Highgate Conservation Area Advisory Committee 18th April 2024

Highgate CAAC objection to application HGY/2024/0458 for 35 Gaskell Road, N6.

Non-Material Amendment to planning permission HGY/2021/0528 to alter glazing to dormer roof, including 3 front velux windows and a flat skylight.

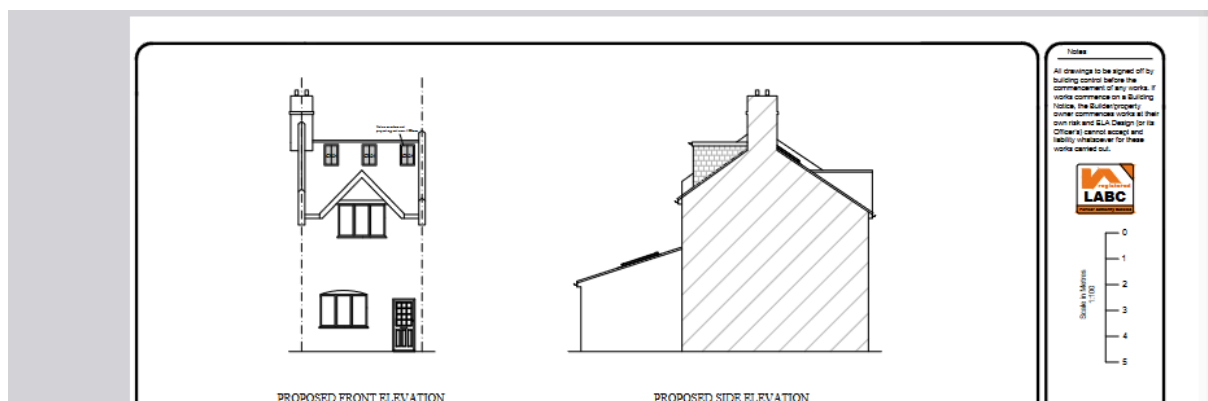
The applicant appears to be proposing three very odd looking rooflights on the front of the property, with four panes, quite unlike the one or two pane Velux windows on the front roof slopes of other houses in Gaskell, Storey, Yeatman and other roads of this estate.

The drawings also suggest that the three rooflights will be very close to the ridgeline, which is also unacceptable.

We object to both of these aspects of the proposed fenestration.
